## ACCESSIBILITY ASSESSMENT REPORT

*Hunter River High School*

Schools Infrastructure

Revision: 2

Figure 7: Designated Set Down Area

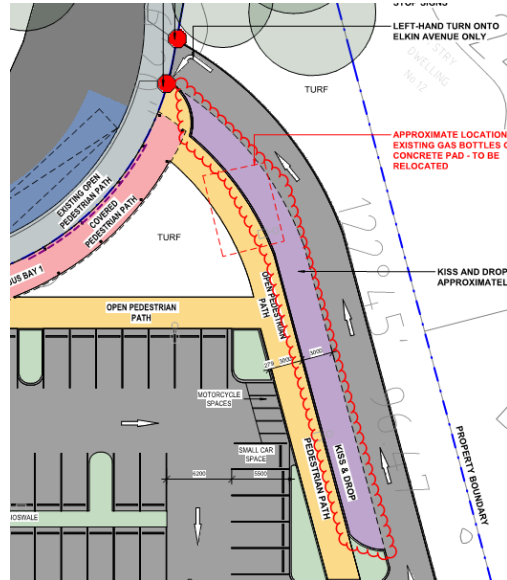
Further detail is to be provided to the setdown area outlined in the figure below. Required features including compliance with AS 2890 series and design around the kerb vs flush kerb, TGSIs, adequate luminous contrast are to be shown demonstrating compliance in updated architectural documentation. This will be further reviewed in DD phase in this regard.

Figure 9: Length of Covered Walkways

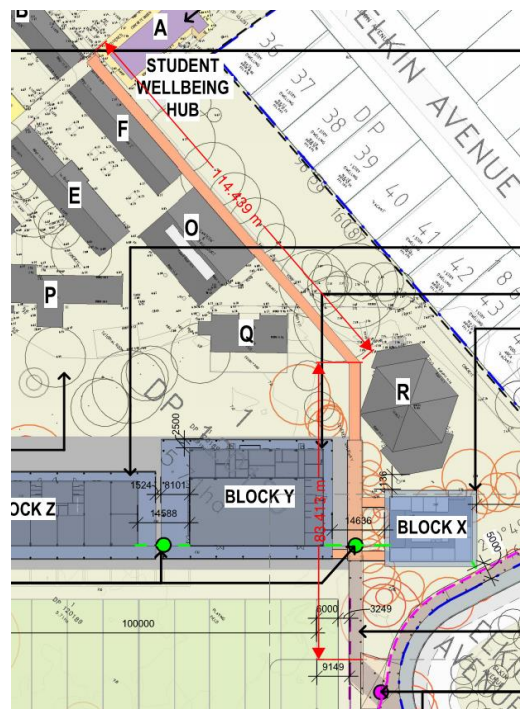
Compliance is readily achievable. Passing spaces are required to be provided at 20m intervals to the covered pedestrian walkways as seen in the figure below. Details of relevant pathway widths are to be provided for review. Architect is to make allowance for sufficient clearances according to this clause.

Figure 12: Block X

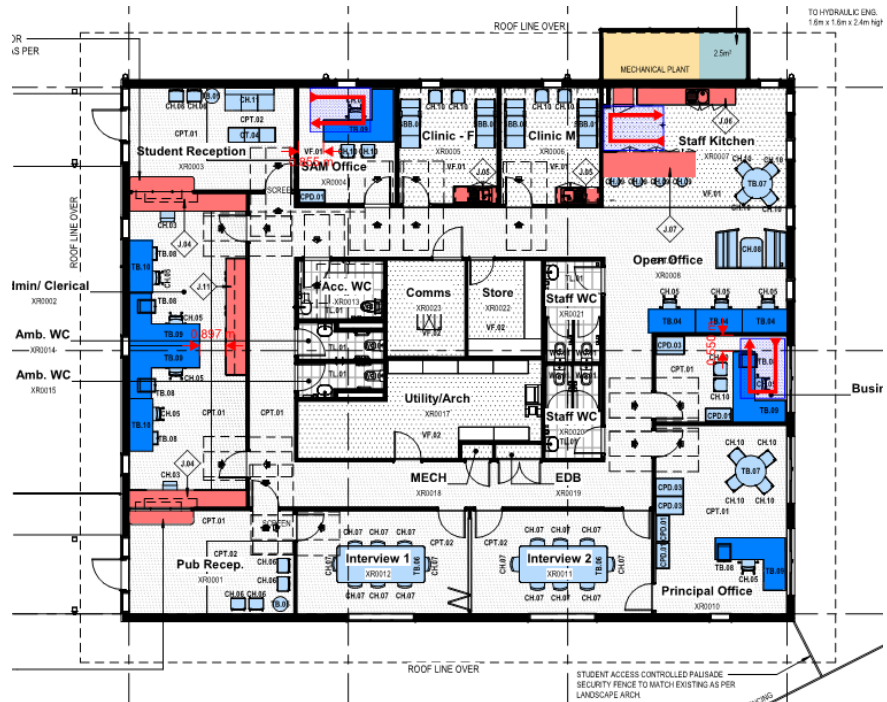
The following will need to be reviewed and addressed through plan amendments and or confirmation that the furniture is movable. The following legend is provided for reference in the below markups.

Figure 14: Gymnasium Circulation Space

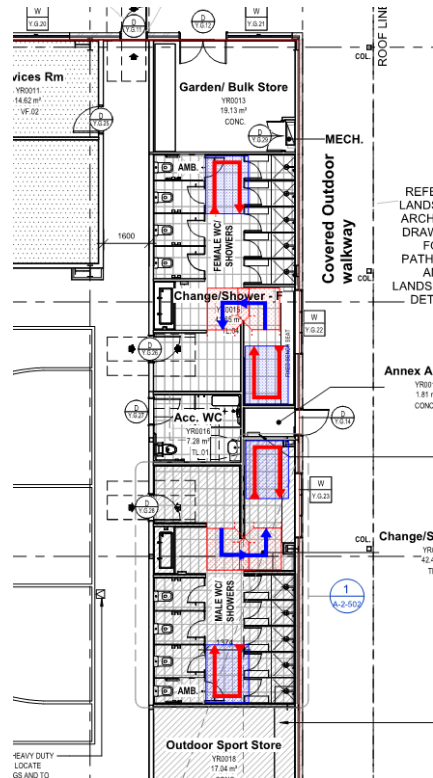
Space for 180 deg turn is not provided within the change areas particularly to the shower areas and the WC areas as such this is to be addressed by way of a performance solution on the basis that there are other accessible facilities provided adjacent to the proposed change rooms.

Figure 21: Block Z – Latch Side Clearances to Sliding Doors

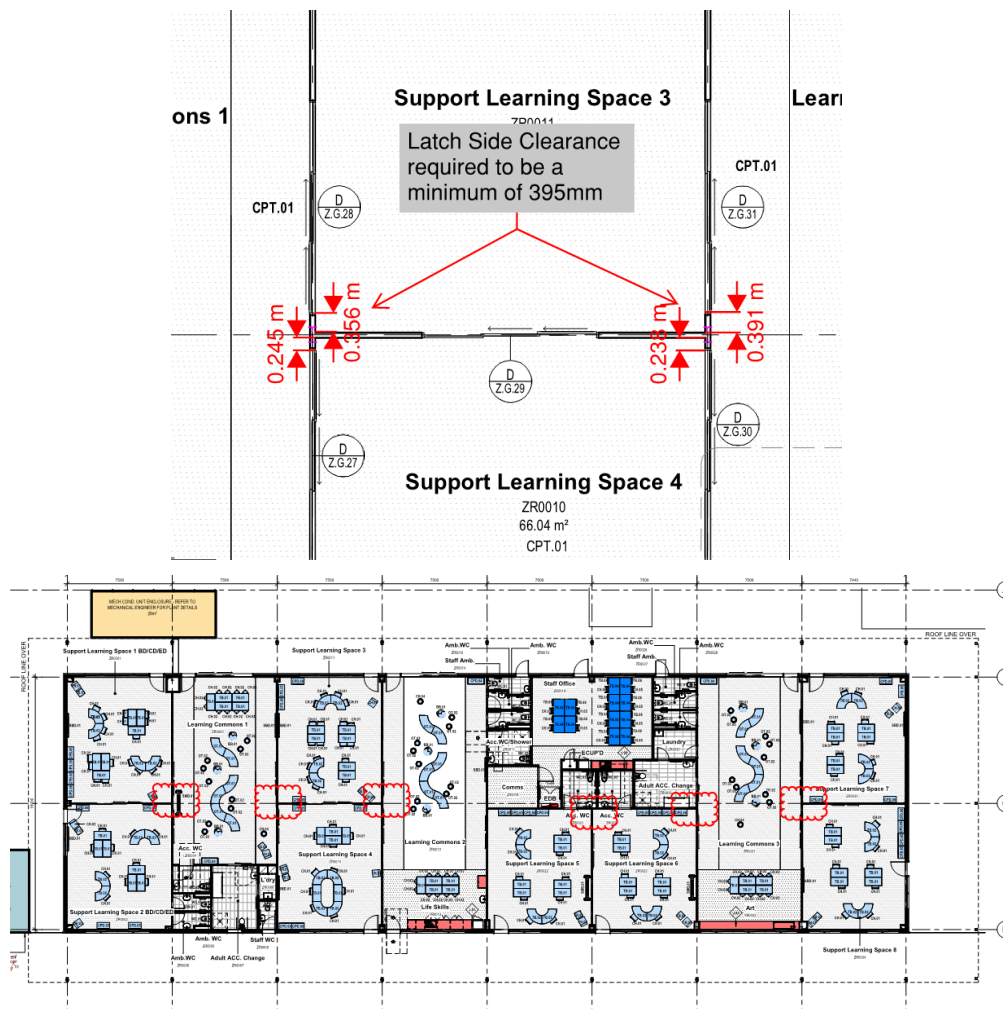
Circulation space does not comply in a number of locations typical examples as shown in the figures below. Circulation space to be reviewed as part of the DD phase and or is to be subject to rationalisation under a Performance Solution. Compliance readily achievable subject to further review as part of the DD phase.

Figure 23: Staff Unit – Circulation Space

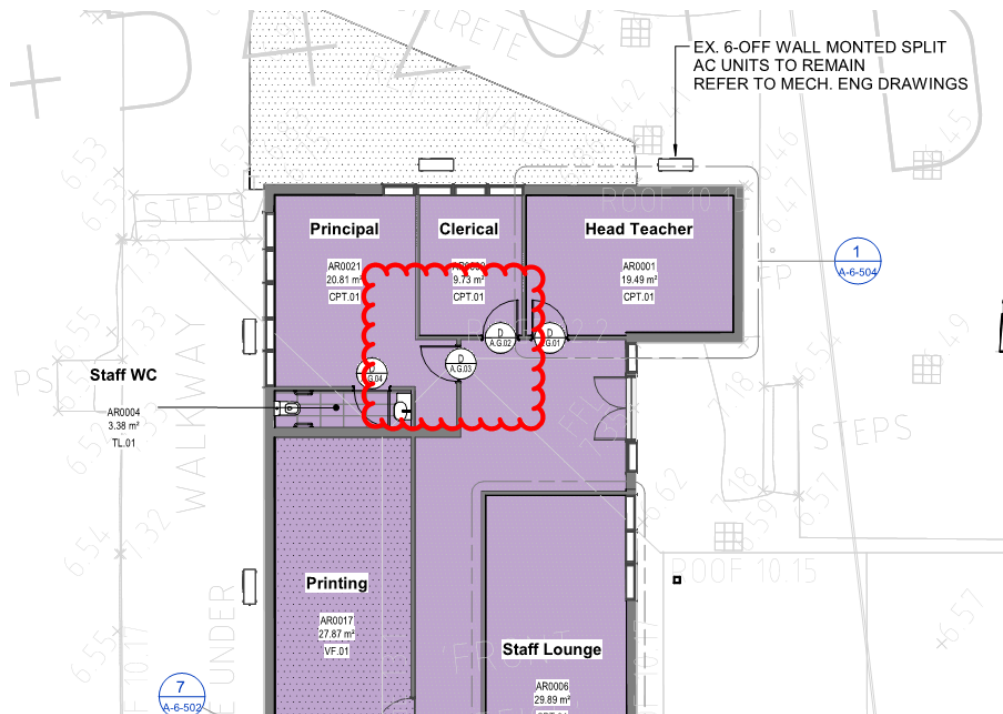
**Important Note:** It has been assumed that the various items within the circulation zone to the various consult rooms and offices are not fixed and comprise movable objects, should these items be fixed joinery units or the like they are to be located outside of the circulation zone. Compliance readily achievable details to be provided along with the DD phase in this regard.

Figure 24: Admin Accessible WCs

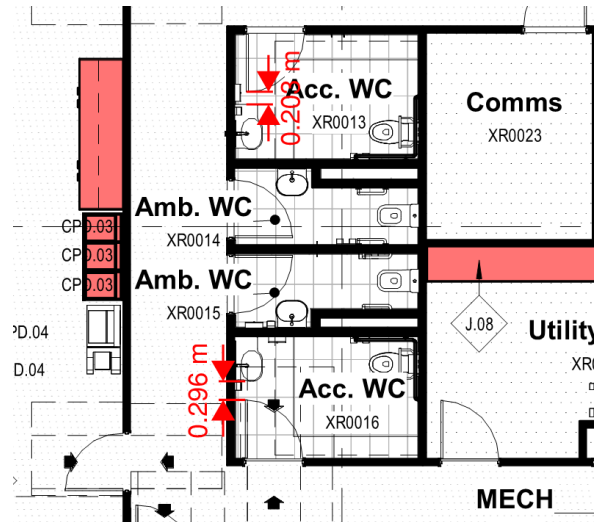
Having regards to the accessible sanitary compartments, the overlapping of circulation space in accordance with cl. 15.6 of AS1428.1-2009 is only permitted where a minimum 300mm setback is achieved from the door leaf. Compliance to be confirmed during DD phase.

Figure 44: Admin Accessible WC

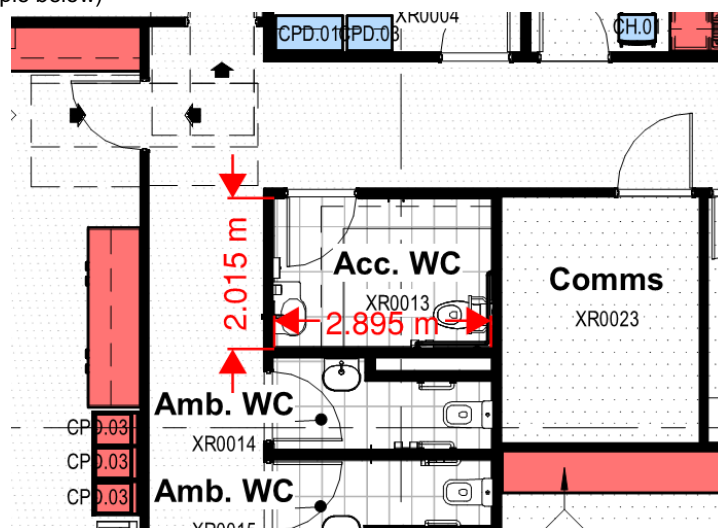
Details demonstrating compliance will need to be provided along with the DD phase, spatially we note that the current size of compartments could readily comply however minimal tolerances within the design however compliance is readily achievable through further design development. (see typical example below)

Figure 45: Gymnasium Accessible WC

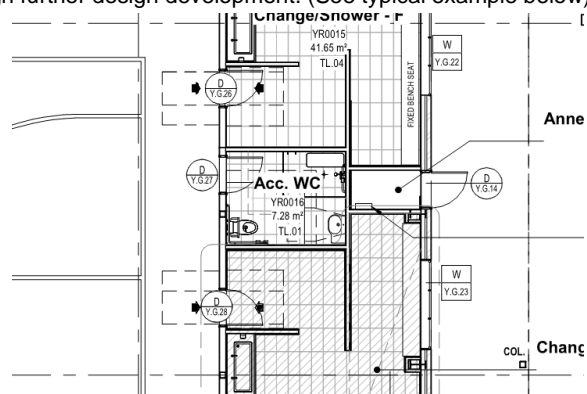
Accessible showers shall comply with AS1428.1 including fixed chair and shower fittings. Spatially we note that the current size of the compartment could readily comply however minimal tolerances are available through further design development. (See typical example below)

Figure 52: Ambulant Clearance Width

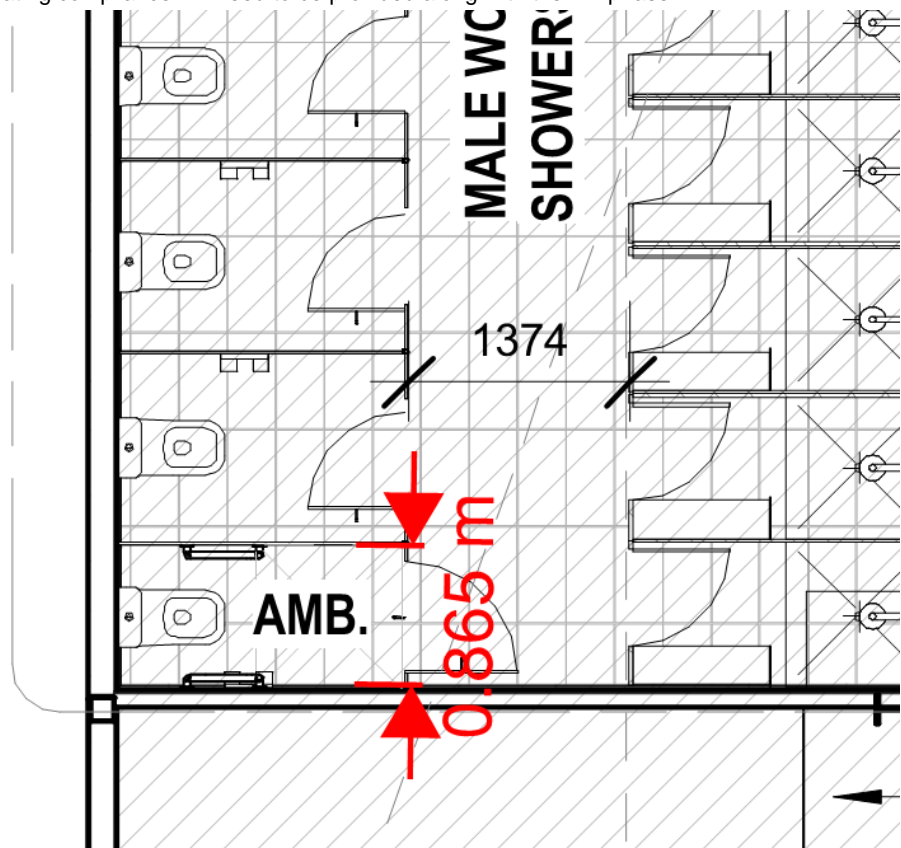
Spatially we note that the current size of the ambulant facilities could readily comply however minimal tolerances are available through further design development. (See typical example below) details demonstrating compliance will need to be provided along with the DD phase.

Figure 53: Ambulant Circulation Space

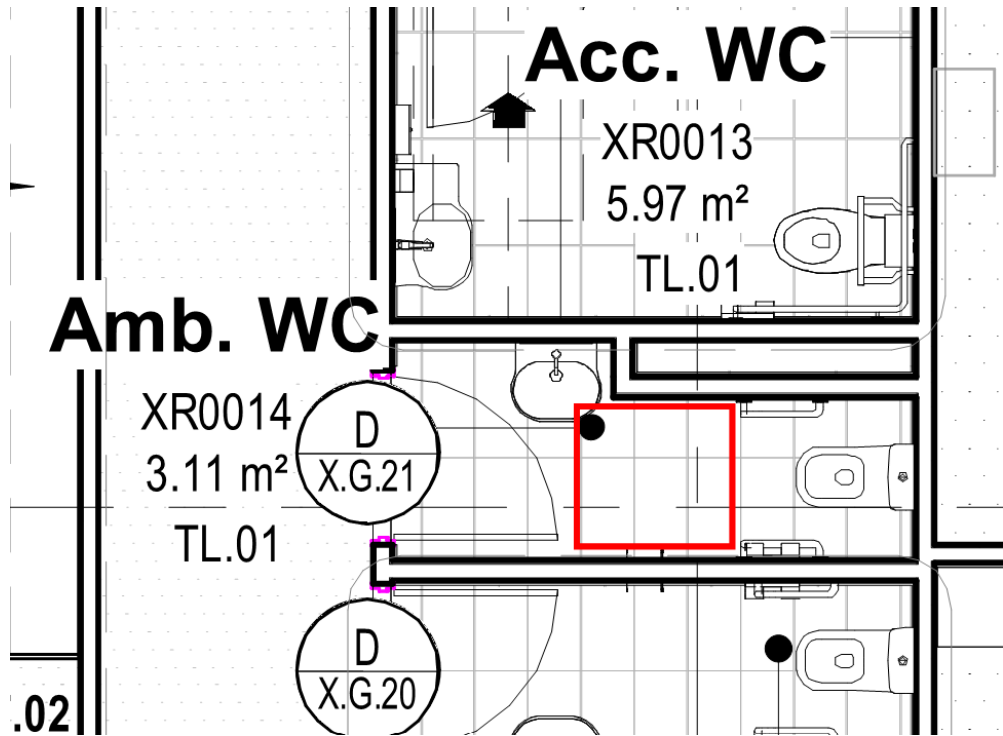
In addition to the above, having regards to the required ambulant facilities we note that there are minor encroachments on the required circulation space this will need to be resolved through the DD phase.

Figure 54: NSL Building Accessible Change Facility

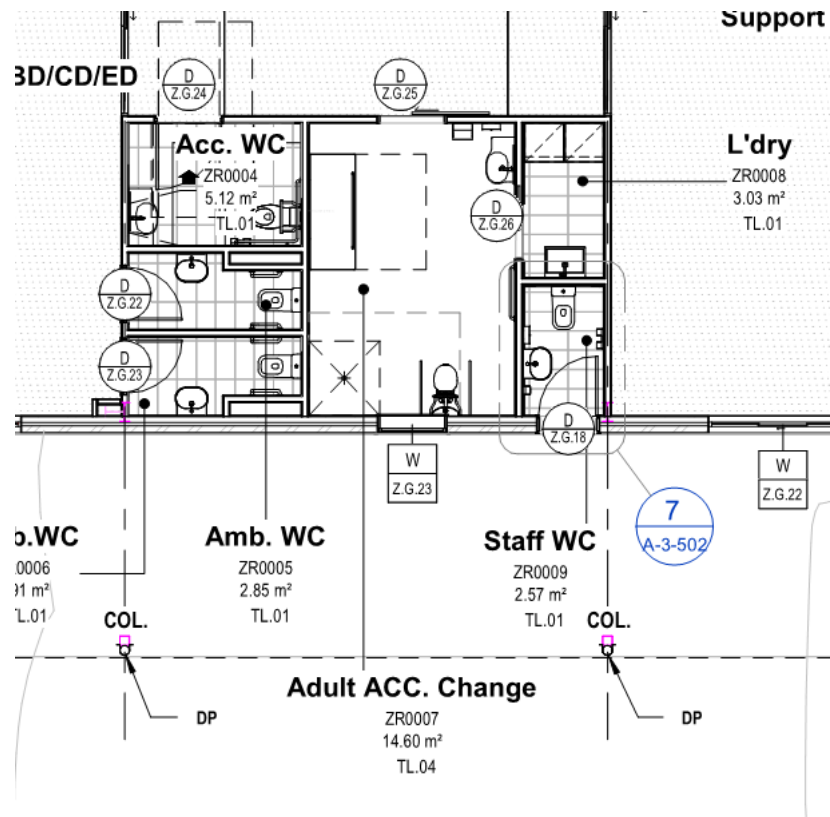
An accessible adult change facilities is proposed, though it is a non-required facility for the purpose of the BCA, it is to comply with F2.9 of the BCA including Specification F2.9. There are a number of issues regarding the circulation spaces and facilities provided with respect to the requirement of Specification F2.9.

Given the lack of details provided it is not clear how this system complies with the required circulation space of the compartment. Provide further detail of compliance at DD stage.

As seen in the figure below, there are a number of the essential required fixtures that have not been provided to the facility. The following items are noted to not be depicted OR do not comply:

- + Change table is to be provided in accordance with Clause 7.
- + Changing rails is to be provided in accordance with Clause 8.
- + Automated sliding entry door to comply with Clause 9. Currently the changing facility is served by a swinging door with a width less than 950mm.

- + Signage is required in accordance with Clause 10;
- + Hoist and operating obstructions required in accordance with Clause 11;
- + Circulation space is to be compliant in accordance with Specification F2.9, see typical layout below;
